MEMORANDUM

SUBJECT: Zoning Commission Case No. 13-08: **Setdown Report** for Consolidated Planned Unit

Developments and Zoning Map Amendments for Square 5914 at Alabama Avenue and 13th

Street, SE

Site Location and Zoning Map

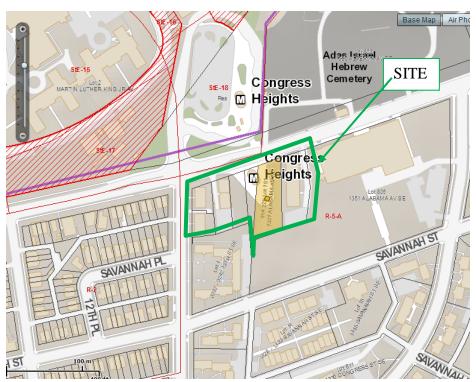
The subject property, Square 5914, Lots 6 and 7 and Parcels 229/160, 229/103, 299/151, and 299/163, has a total land area of 88,486 square feet (2.03 acres) and is located between 13th Street, SE on the west and Malcolm X Elementary School on the east and along Alabama Avenue to the
